LMR14050-Q1 Interference issue

# Problem Description

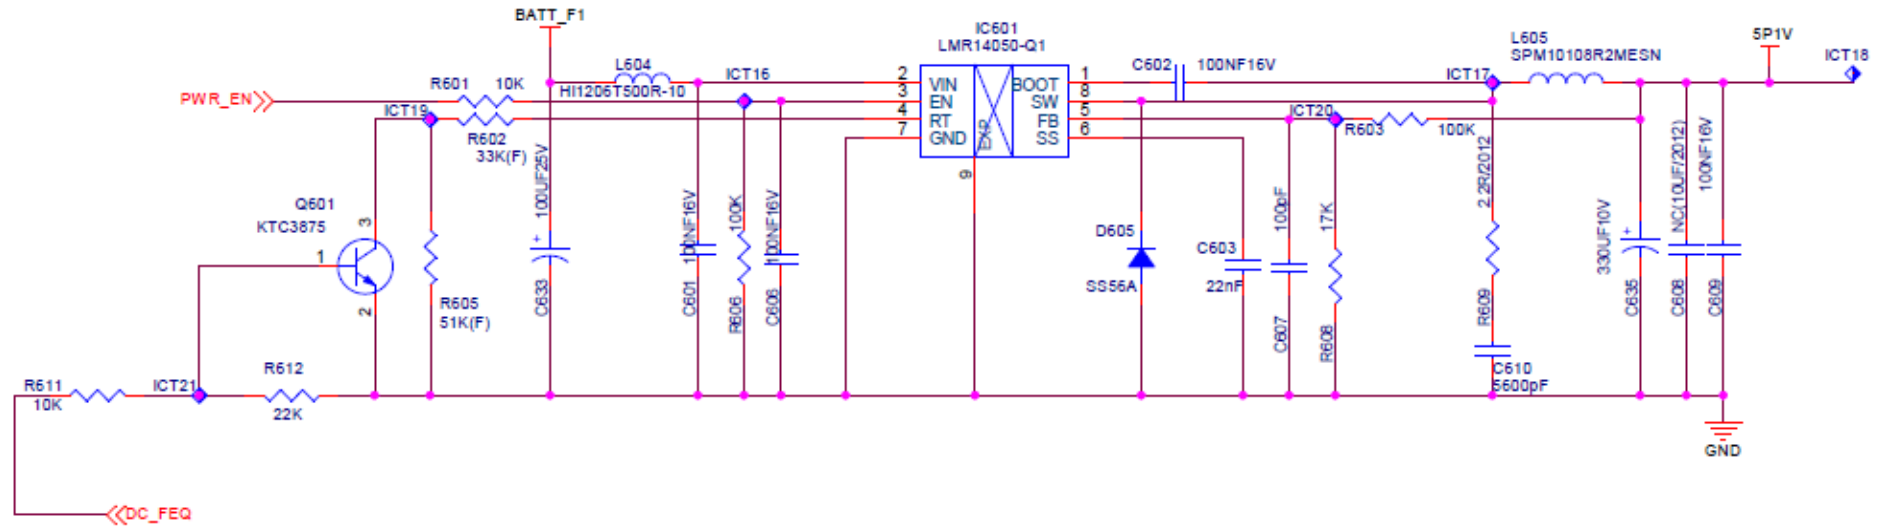
- LMR14050-Q1 of TI (Current : 5A max)
  - Location No : IC601
  - Observed ringing, overshoot and undershoot at rising and falling edge
  - Especially FM reception sensitivity can not meet customer spec
